MEMORANDUM

PROJECT: Fairland Road Improvements
From Columbia Pike (US 29) to Prince George's County
CIP Project No. 509337

REVIEW TYPE: Mandatory Referral No. MR# 02813-DPW&T-1

RECOMMENDATION: APPROVAL WITH COMMENTS TO DPWT

ATTACHMENT 3

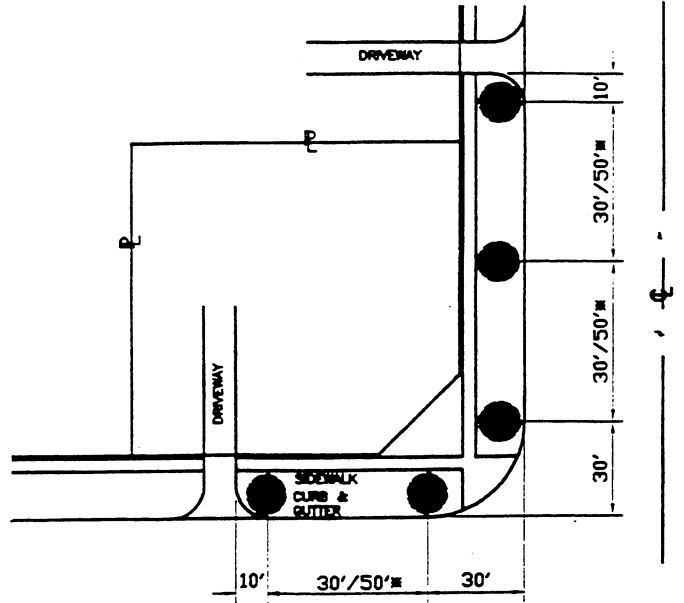
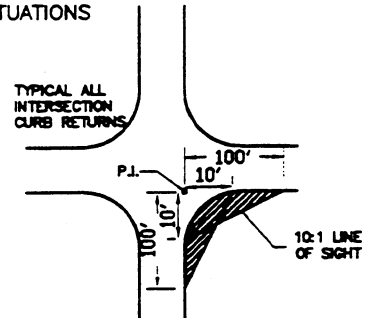
5. The proposed landscape panel between the curb and sidewalk should be seven-foot wide. Landscape panels should be planted with street trees in areas without closely-spaced driveways.

The issue of where street trees should be located was discussed during the facility planning of this project but was not resolved. The typical location per the County's road standards on closed section roads is between the curb and sidewalk (see Attachment 3).

ATTACHMENT 4

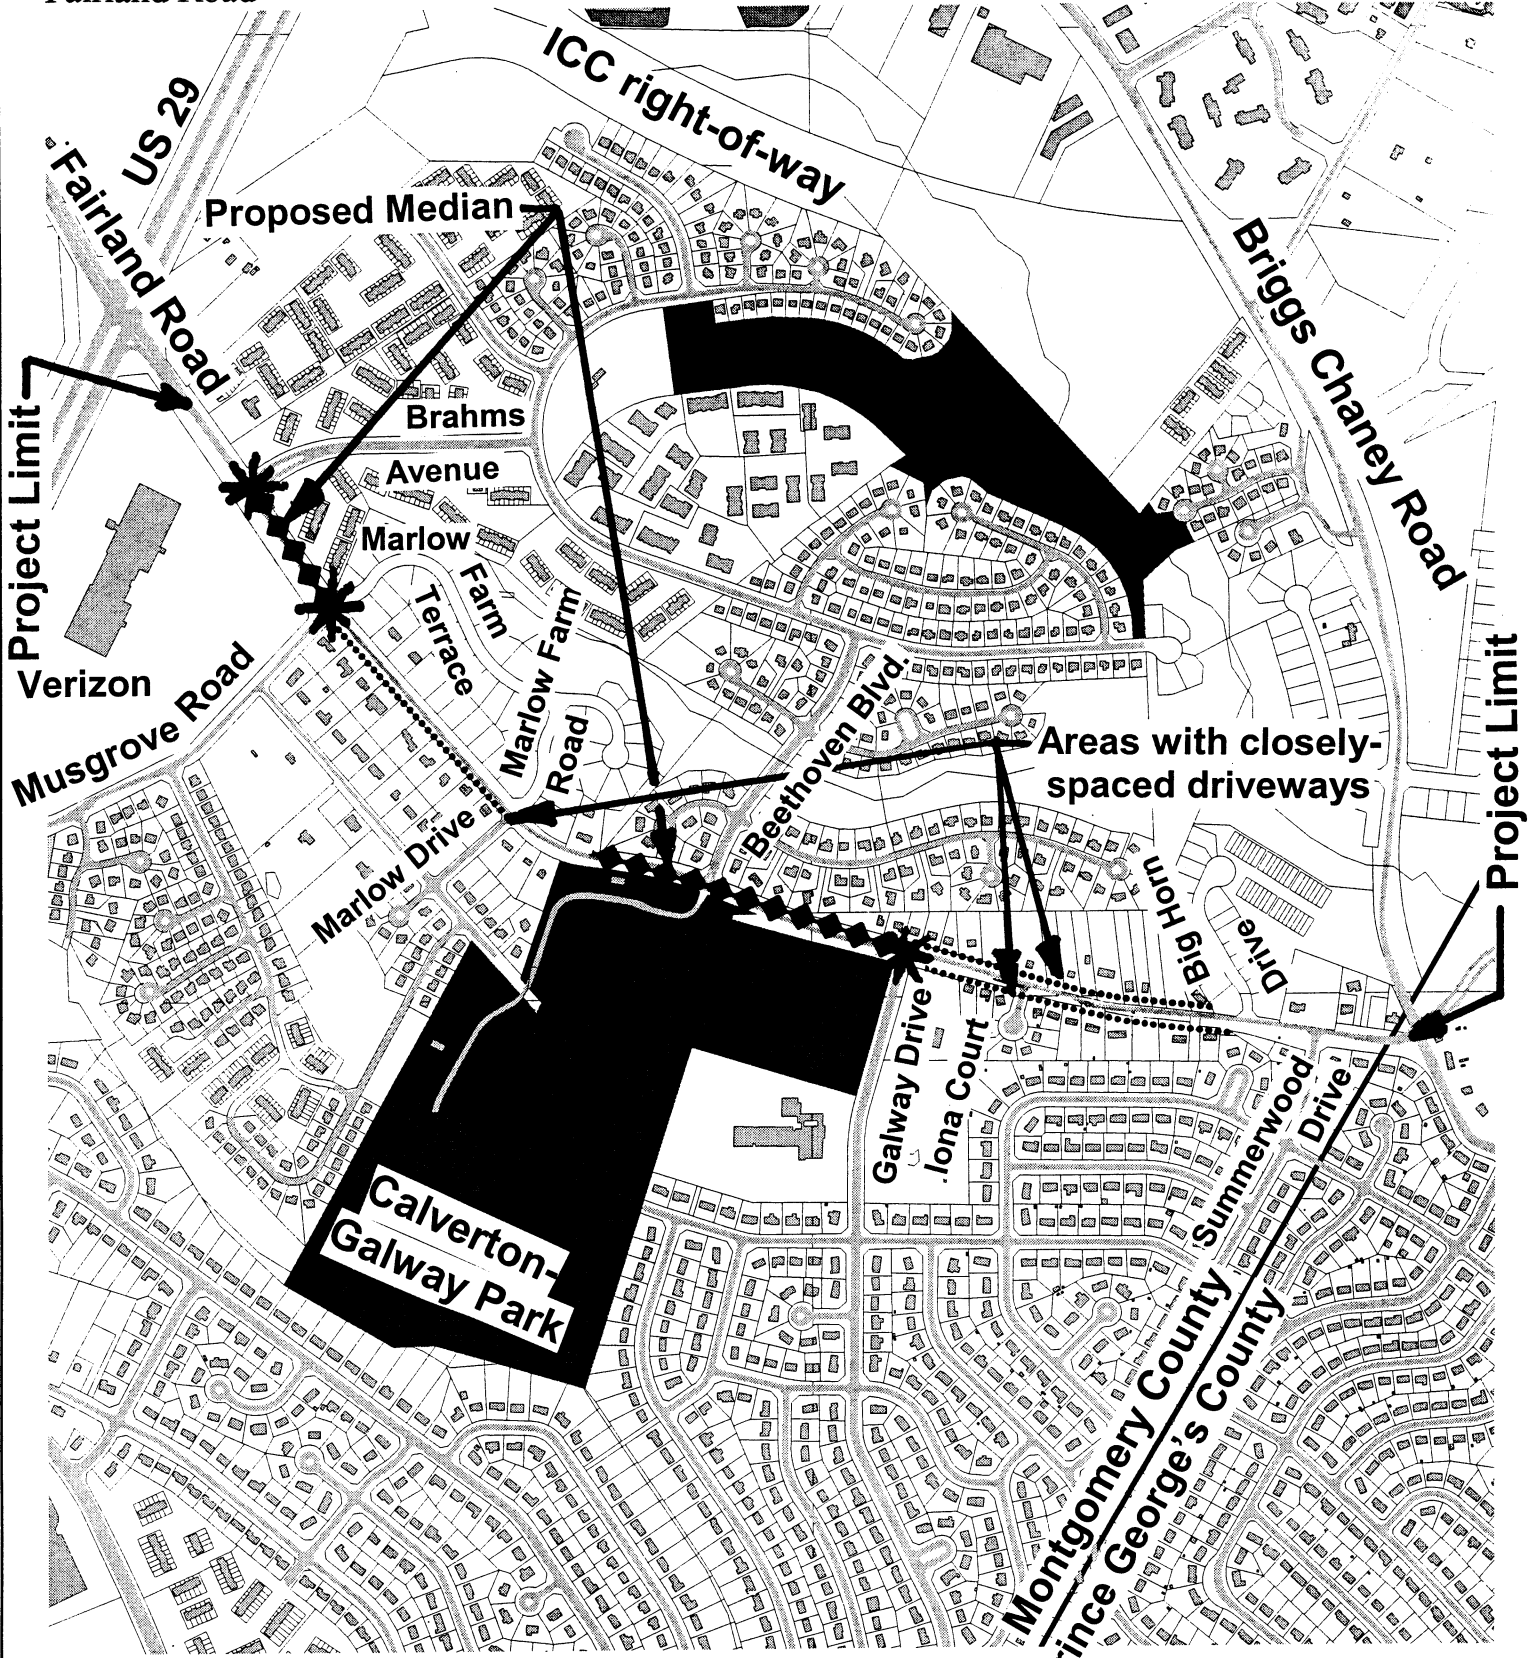
There are two areas within the project limits where there are closely-spaced driveways: on the south side of Fairland Road between Musgrove Road and Marlow

Place, and along both sides of Fairland Road between Galway Drive and Big Horn Drive. These areas are shown as Attachment 4. Staff believes that the driveways are a reasonable concern, but one that in this case is alleviated by the proposed four-foot wide on-road bike lanes. Drivers should have an unobstructed view of oncoming traffic without pulling out into the travel lane. Staff agreed not to contest moving the trees to the back of the sidewalk in these areas, but DPWT has insisted that all trees be moved to the back of the sidewalk.

Exhibit 1-10. Typical urban single-lane roundabout.

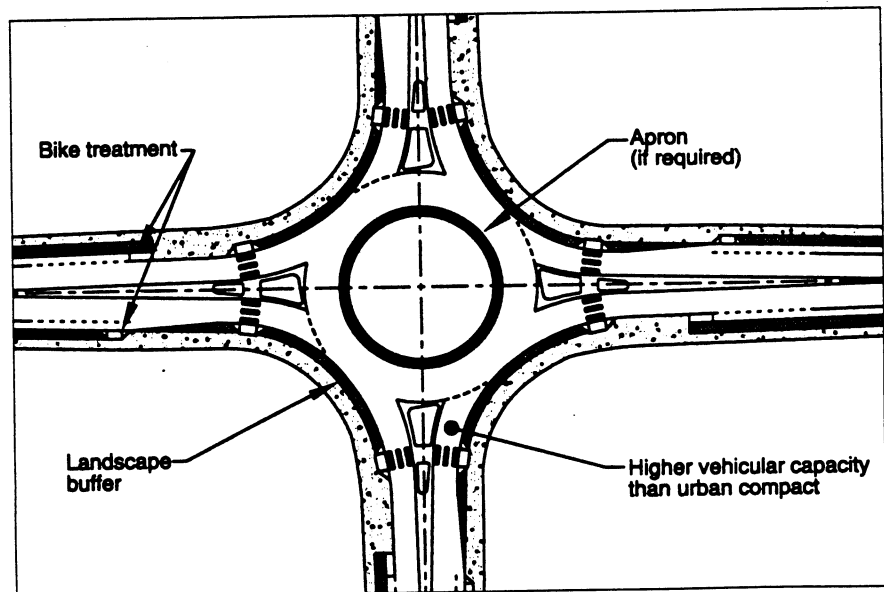
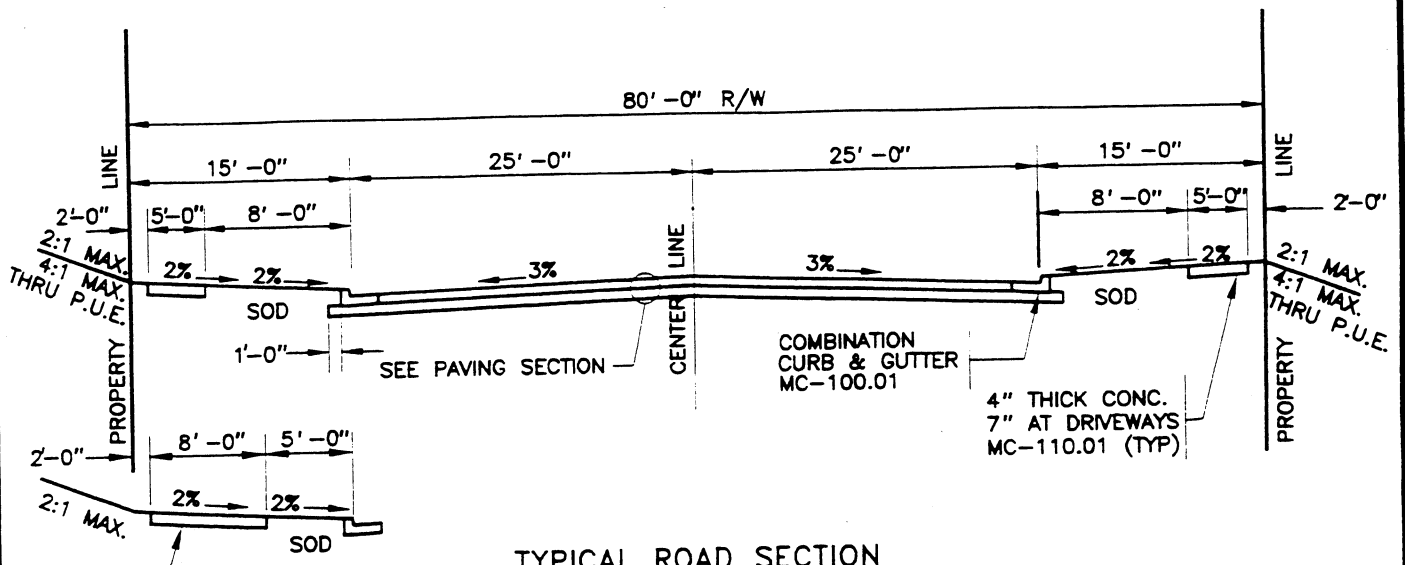
Attachment 8 is an excerpt from this guide illustrating the urban single-lane roundabout. The left side of the diagram has an arrow to a second set of ramps on this leg of the intersection with the designation "bike treatment". These ramps would allow bicyclists the option of riding on the sidewalk through the roundabouts area. Beyond the ramps the roadway is narrowed to force bicyclists who wish to remain on-road through the roundabout to share the travel lane with other vehicles, reducing the potential for angle collisions around the central island. ***Staff recommends that the design for the proposed roundabouts be modified to reflect these bicycle features.***

Exhibit 7-24. Landscaping of the central island.

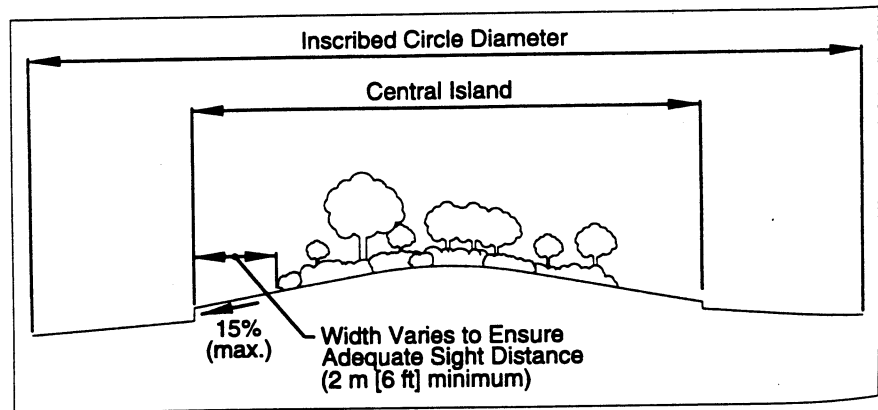
8. Plant ornamental trees and other landscaping in the proposed roundabouts. Provide an enhanced landscape treatment at other intersections to provide a transition between segments of roadway with different street tree locations.

Staff recommends that ornamental trees and other landscaping materials be planted in the proposed roundabouts. As noted in Attachment 10, from the FHWA guide referenced above, landscaping in the central island helps to enhance the safety of the intersection by making it a focal point and lowering speeds. Well-designed landscaping would also help to mitigate the intrusion posed by the size of the roundabouts, which would bring the roadway closer to homes and apartments than the existing intersection. Good landscaping would help to make the central island a visual asset.
